CERTIFICATE OF APPROPRIATENESS

Property: 544 Harvard Street, lot 23, block 289, Houston Heights Subdivision. The property includes a historic 1,707 square foot, one-story wood frame single-family residence situated on a 6,600 square foot (50' x 132') interior lot.

Proposal: Alteration – Revision to COA granted by Planning Commission in October 2014.

The applicant now proposes to relocate the front porch steps from the north side to the west (front) and add brick wing walls with concrete caps.

WEST ELEVATION – FRONT FACING HARVARD STREET

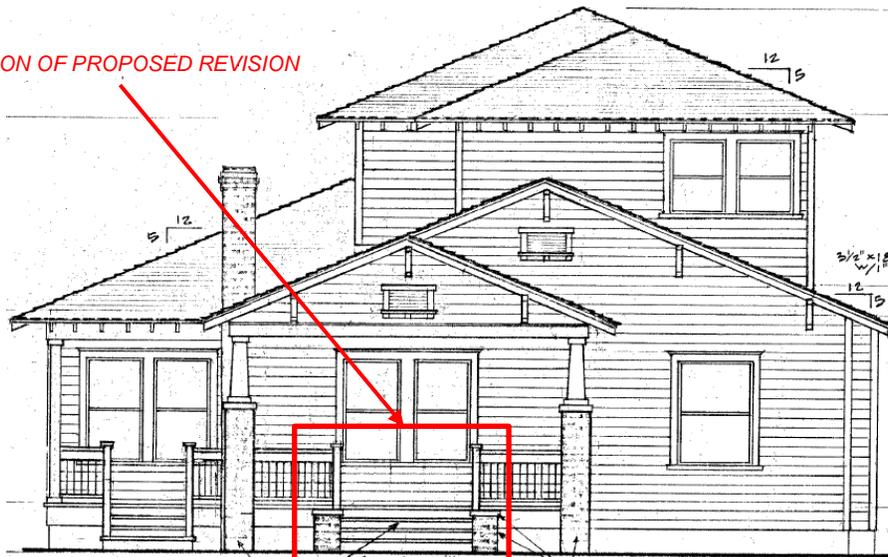
Front Elevation: As approved, the front porch features a full-width wood railing. Concrete steps measuring 7' wide
(West) are now proposed to be centered on the porch with a pair of brick wing walls measuring 1'-4" wide with concrete caps no higher than the porch floor.

While I don't usually object to the placement of stairs on the front elevation that face the street, in this case, without a door in the façade, the stairs really go to nowhere visually and look awkward. There are many examples of side facing doors with steps from the side of the house. This steps and no door relationship is not supportive of the character of the district. The steps should remain from the side as in the original proposal. I have no objection to the brick wingwalls on the steps if the steps are to the side. However, if the steps are allowed in the front toward the street, they should not be more embellished with brick than the side steps. Placing brick on front facing steps just exacerbates the visual steps-to-nowhere look.

NORTH SIDE ELEVATION

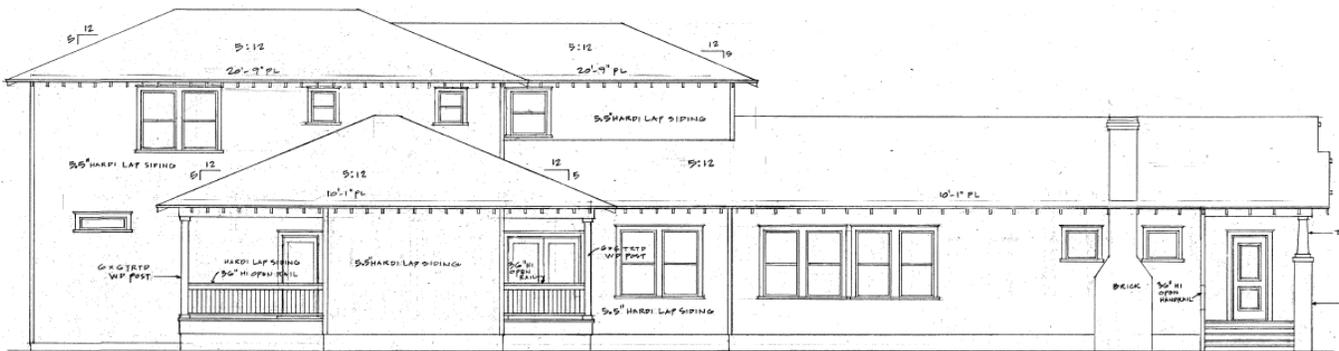
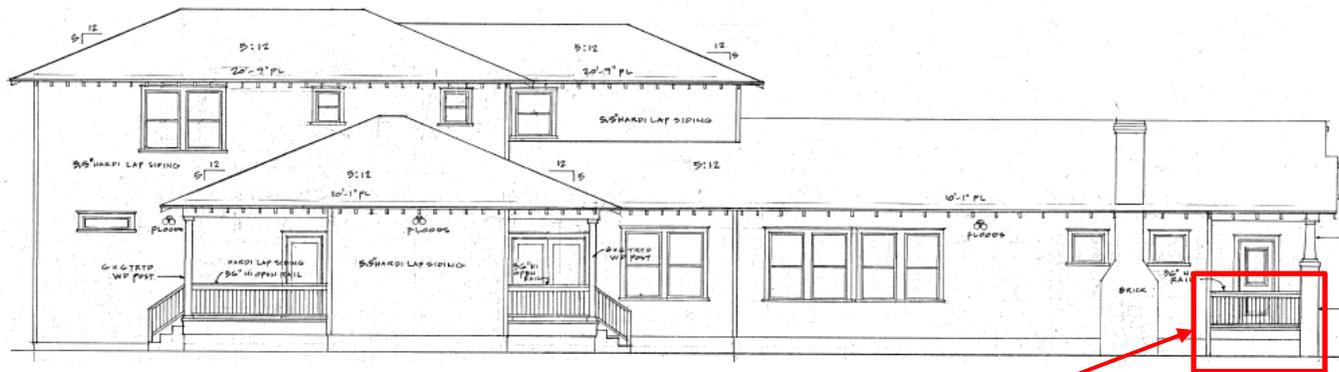
Side Elevation: As approved, the front porch features full-width concrete steps. No steps are now proposed for
(North) this side of the porch, and a full-width wood railing will be installed.

PORCH DETAIL

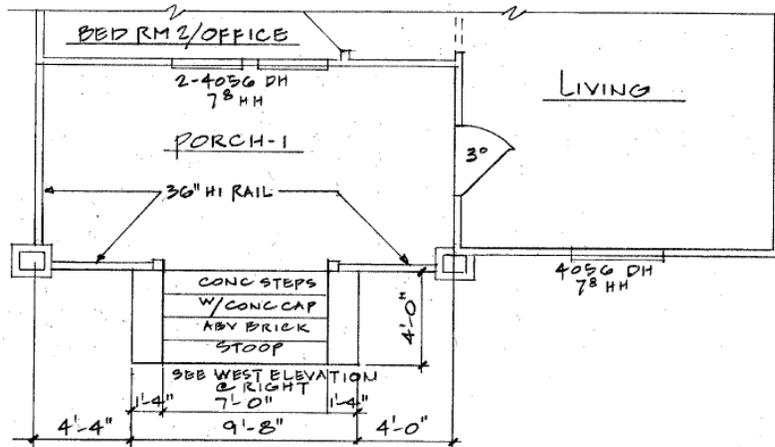
Exterior Materials: The approved COA includes a wood rail across the front porch and full width concrete steps on the north side of the porch. The steps are now proposed to be constructed on the front (west) flanked by a pair of 4' long by 1'-4" wide brick wing walls with concrete caps no higher than the porch floor. The north side of the porch will feature a wood railing.
